Overview: Production error in version 1.0 harnesses; The immobilizer wire (orange/black) is in pin position #4 instead of pin position #5. Although an effort to correct the issue was made, some quantity of harnesses did get shipped before the issue was spotted. We are advising to inspect the harness BLADE connector before attempting to install harness or program the module. This issue is not known to affect the version 2 harnesses, which require no modification.

FTI-STP1: Notas de instalación y configuración

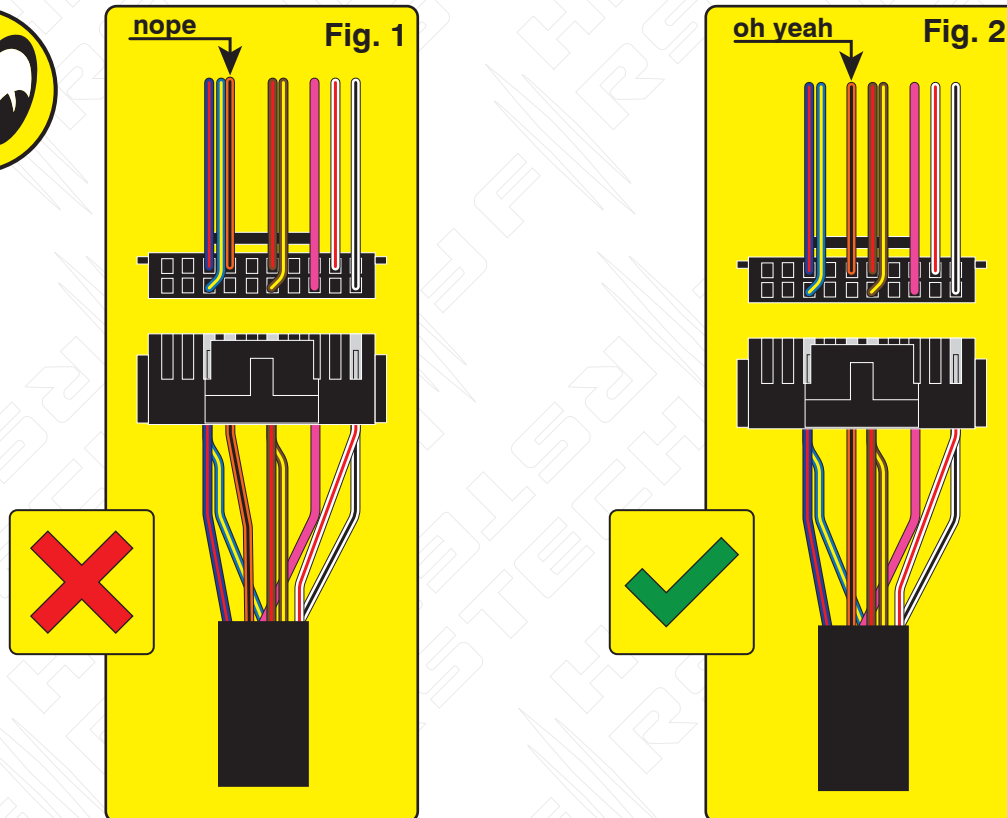
Correction: Step 1.) Locate the orange/black wire and confirm whether it is positioned as illustrated in Fig. 1 or Fig. 2. If the wire is as illustrated in Fig.1, proceed with Step 2 through 5 and complete the repair procedure outlined, if the wire is as illustrated in Fig. 2, correction is not necessary, proceed with harness installation and module programming.

Step 2.) Using a pick, lightly depress the catch that secures the terminal in the housing then remove the wire and terminal from the housing.

Step 3.) Using a fine tip razor or utility knife, insert the blade beneath the terminal catch and raise it slightly, so that it can be reused to secure the terminal when reinserted into the BLADE connector housing.

Step 4.) Refer to Fig. 2 for correct position of the orange/black wire (next to brown/red) then reinsert the terminal, pressing lightly until the catch 'snaps' into place, securing the terminal in the connector housing.

MODIFICACIÓN REQUERIDA PARA APLICACIONES A/T, SÓLO CON ARNÉS v 1.0

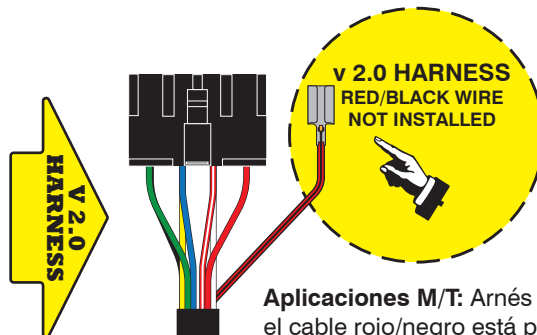
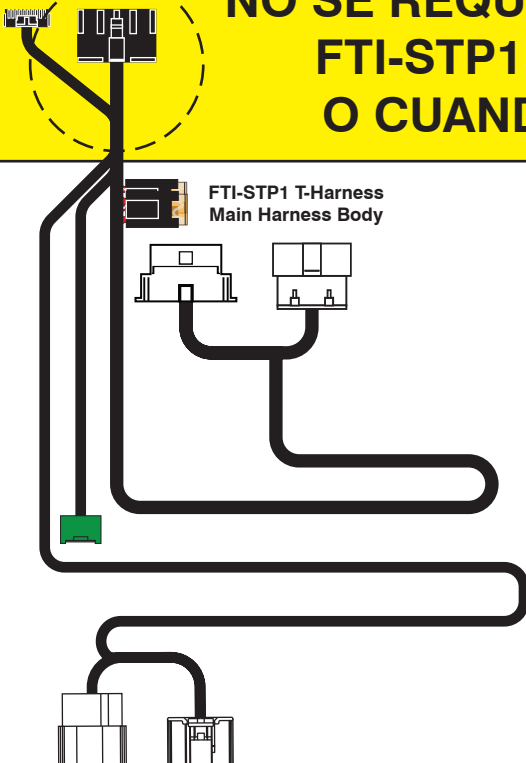
Problema: El arnés en T FTI-STP1 ha sido diseñado para ser compatible con A/T (transmisión automática) y M/T (manual), pero debido a un descuido en las primeras ejecuciones de producción, la selección se estableció por defecto en el modo M/T.

El uso de un arnés configurado para una aplicación M/T, en un vehículo equipado con A/T, podría provocar daños en el módulo del vehículo, se recomienda que el arnés vuelva al modo A/T antes de la instalación en vehículos equipados con transmisión automática.

Corrección: Localice el cable rojo/negro (+ embrague) proporcionado en el conector CN1 del conjunto del arnés principal. Corte el cable rojo/negro, ya sea al ras del conector CN1 o dejando suficiente cable expuesto para que pueda aislar y asegure los extremos del cable que quedan después del corte. Aísle cada uno de los extremos restantes del cable rojo/negro y asegúrelos para evitar cualquier posibilidad de cortocircuito. Si el cable rojo/negro ya ha sido desconectado, ninguna modificación adicional se requiere para aplicaciones A/T
